Council Agenda Correspondence

SUBJECT: Item 6b – ARCH-0406-2021; SBDV-0407-2021; GENP-0814-2019; SPEC-0407-2020; & EID-0608-2020 (600 Tank Farm) Agenda Correspondence Staff Response Memo

Figure 1: Inclusionary Housing Plan

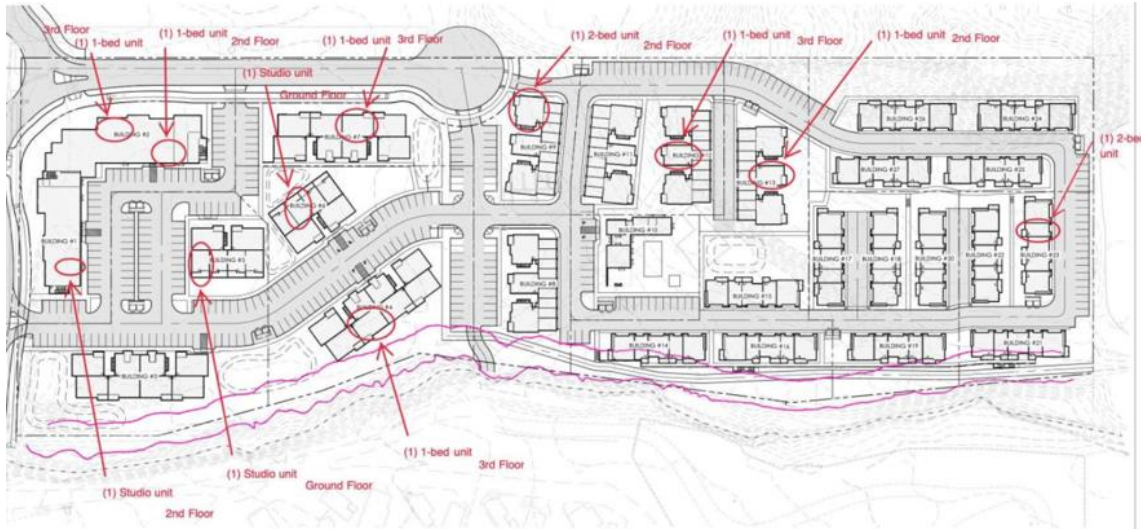
2. *On page 228 of the packet, it notes that there are 11 moderate income units being proposed and that is more than required (3, only). Where are those located and are they evenly distributed throughout the project? I don't remember seeing the size or locations of those units noted on the plans.*

Response: The 11 units would be spread throughout the project site, and would include a variety of housing types, including studios, 1-bedroom and 2-bedroom units. The location of these units was shown in Figure 5 of the [Planning Commission Report of November 17, 2021](#), as well as Sheet C4 on the project plans, and will be discussed and shown in tonight's City Council presentation, but for reference is also shown here.

Figure 2: Santa Fe Road section cuts

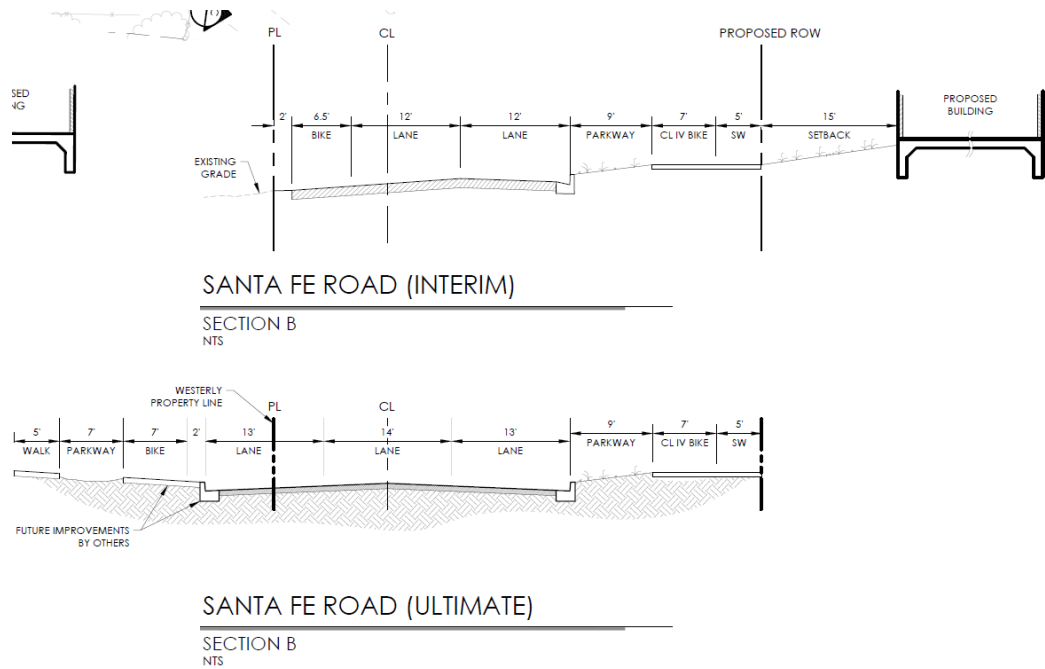
3. On page 259, see this item:

117. Santa Fe Road Extension. Project applicant shall be responsible for constructing a portion of the Santa Fe Road Extension north of Tank Farm Road, extending approximately 570 feet north of Tank Farm Road. Unless otherwise approved by the Public Works Director, plans submitted for Public Improvement Plans shall include the following typical cross section elements listed from east to west: 5' sidewalk / 7' protected bike lane / 9' parkway / curb and gutter / two 12' auto lanes / 6.5' bike lane / 2' shoulder.

Is there a reason that we didn't just do 7 ft protected lanes on both sides? (I'm assuming this is protected going one direction and one un-protected going the other?)

Response: Yes, the developer is required to construct the permanent street improvements along their frontage and 2/3 of the ultimate street – minimum auto travel lanes and a striped Class II bike lane on the west side to provide at least a dedicated interim southbound bike lane until either the Chevron property develops or Santa Fe Road is extended north to the future Prado Road Extension. The interim and ultimate road section for Santa Fe from the 600 Tank Farm plans are shown in Figure 2 below. Until the Chevron property develops or Santa Fe Road is extended further, a striped Class II bike lane operate per the volume/speed thresholds in our ATP (at this time, Santa Fe will carry <1,000 veh/day with speeds of 25 mph).

Figure 6: Portions of Buildings 4, 8, 14, 19, and 21, third story encroachment within the additional 10-foot upper story setback.

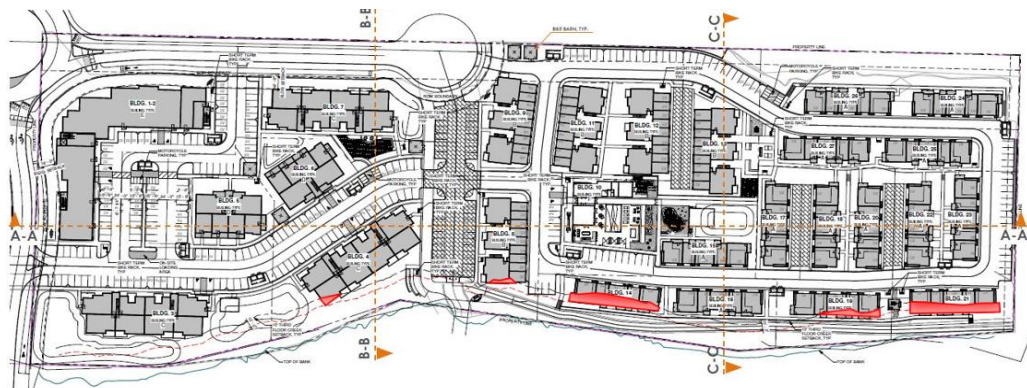
5. I had questions about the creek setback waiver that staff is recommending for this project. 2 feet from 35? I also would like to hear about the details on the second-story setback waiver (45 to 30 I think it is)?

- Portions of Buildings 14 and 21 encroach within the setback by 5-feet or less, resulting in 30-foot setback from the top of bank, where 35 feet would normally be required (see Figure 5 below).
- Portions of Buildings 4, 8, 14, 19, and 21, along the third floors, encroach within the upper-story setback by up to 15 feet (see Figure 6), resulting in a setback of 30 feet from the top of bank, where 45 feet is normally required for the third floor.
